**PLANNED UNIT DEVELOPMENT  
& SUBDIVISION STAFF REPORT****Date: August 6, 2015****DEVELOPMENT NAME**

Trailways Subdivision

**LOCATION**2521 Halls Mill Road  
(Northeast corner of Halls Mill Road and Navco Road)**CITY COUNCIL  
DISTRICT**

Planned Unit Development Approval to allow multiple buildings on a single building site, and Subdivision approval to create 1 lot.

# SITE PLAN

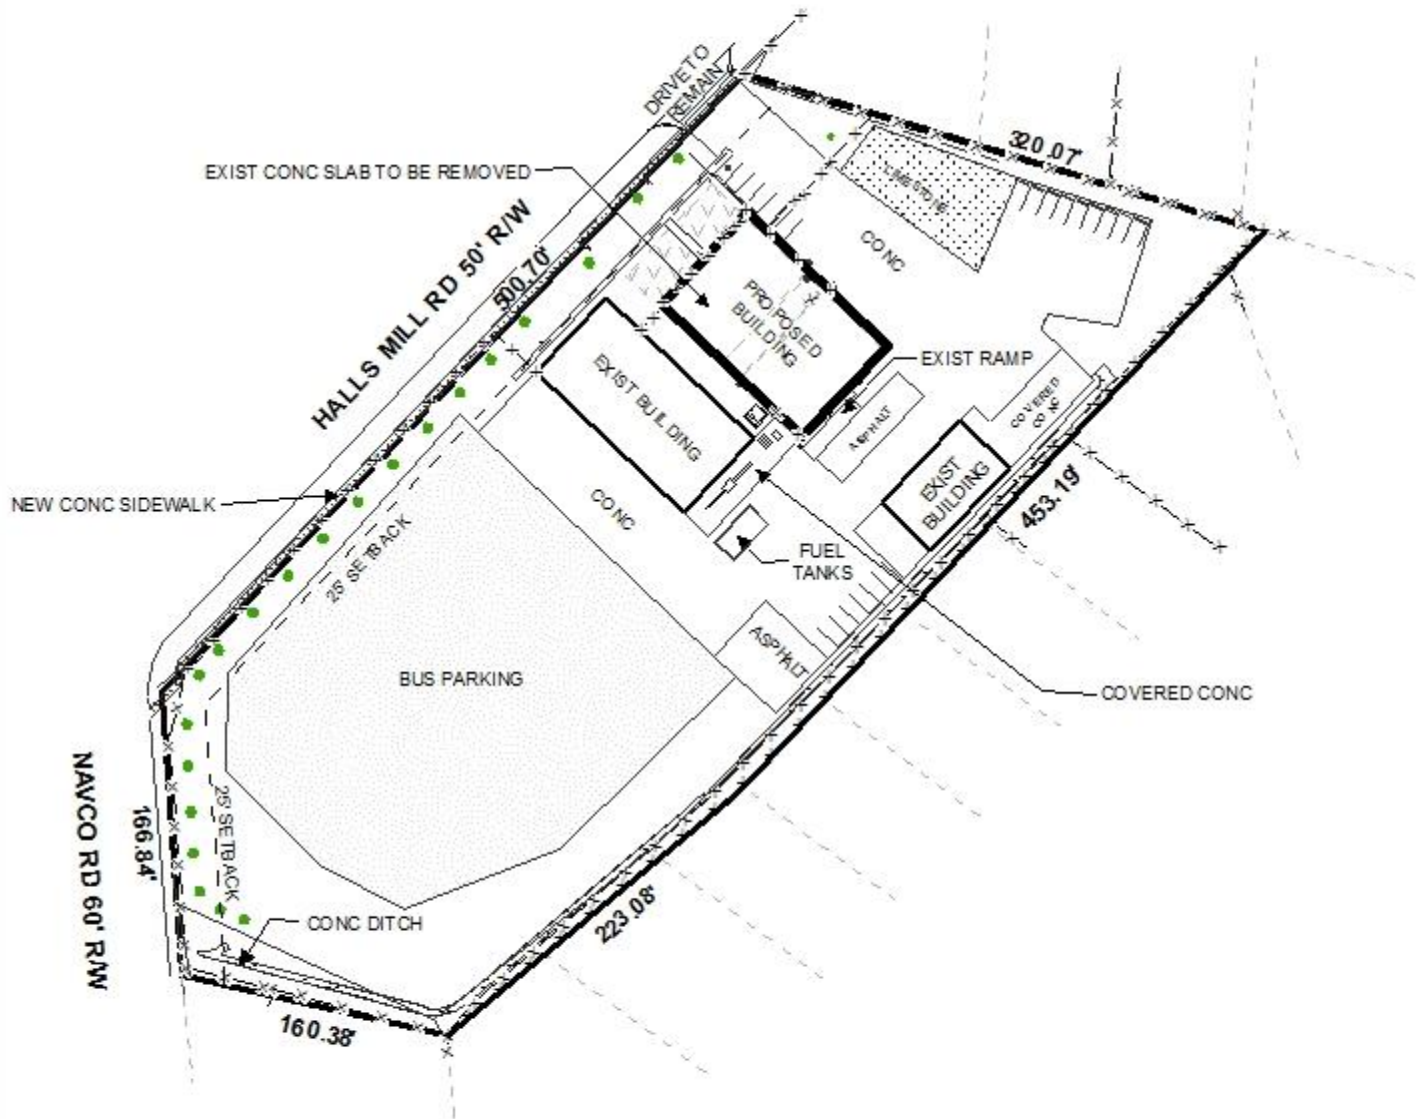
The portion of the site on which the proposed and existing structures are situated is paved, as required by the Zoning Ordinance regarding B-3, Community Business Districts to facilitate access and parking. The site plan depicts thirteen (13) existing parking spaces, one of which is handicap accessible, and proposes an additional nine (9) parking spaces to comply with current parking requirements of the Zoning Ordinance for commercial office and warehouse space, including stall length and width, and the provision of bumper stops. It should be noted there are two existing structures on the site whose uses are not provided; therefore it is difficult for staff to determine if the site will have sufficient parking. The site on which busses utilized by the existing business are stored is surfaced with aggregate material. Aggregate surfacing is only allowed by right in I-1, Light Industry, and I-2, Heavy Industry districts. However upon review and as the applicant mentions, the property has been used in its current capacity since at least 1991; additionally, aggregate surfacing is verified by Staff to have been visible in aerial photos since at least 1997. As a result, the existing surfacing may be considered non-conforming and

Landscaping is proposed on the site plan, specifically, the provision of frontage trees, landscape area, and a new sidewalk. Since the site was developed prior to 1992, and the total gross floor area of existing and proposed structures on the site is neither increasing nor decreasing by fifty (50) percent, full compliance with landscaping is not required. However, the Commission does typically request frontage trees for Planned Unit Developments.

It should be noted that the site abuts an R-1, Single-Family Residential District to the East and, as a B-3, Community Business District, a protection buffer is required per Chapter 64-4. D.1. of the Zoning Ordinance. A chain-link fence is confirmed to have enclosed the site since at least 2007, facilitating what appears to be a vegetative buffer between the two zoning districts. However it does not appear to be 10' wide, as required; therefore an appropriate protection buffer in the form of a wall, wooden privacy fence, or the inclusion of a screen planting strip is recommended to ensure compliance with the aforementioned protection buffer requirements and should be illustrated on any revised site plan(s).

A dumpster is not depicted on the site plan and one is not visible in recent aerial photos. Any dumpster placed on the property must be in compliance with the current enclosure and sanitary sewer connection requirements of Section 64-4.D.9. of the Zoning Ordinance and must be illustrated on any revised site plan(s), or placement of a note on the site plan stating that curbside pickup will be utilized, if approved.

It should be noted that the vicinity map on both the preliminary plat and site plan are not accurate and should be corrected.

- 5) placement of a note on the site plan stating that the Lot is limited to the existing curb-cuts, with size, location and design to be approved by Traffic Engineering and conform to AASHTO standards;

- 6) depiction of the building setback line for the Lot on the site plan, adjusted for any right-of-way dedication;

- 7) placement of a note stating the lot sizes in square feet and acres on the site plan, or the furnishing of a table on the site plan providing the same information, adjusted for any right-of-way dedication;

- 8) revision of the site plan to illustrate compliance with Section 64-4.D.1. of the Zoning Ordinance regarding a required buffer between the site and the Single-Family Residential District to which the site abuts;

- 9) revision of the site plan to illustrate compliance with Section 64-4.D.9. of the Zoning Ordinance regarding dumpster requirements, or a note stating curb-side pickup will be used;

- 10) revision of the vicinity map to show the subject site;
- 11) any new site lighting to comply with Sections 64-4.A.2. and 64-6.A.3.c. of the Zoning Ordinance (photometric plan is not required);
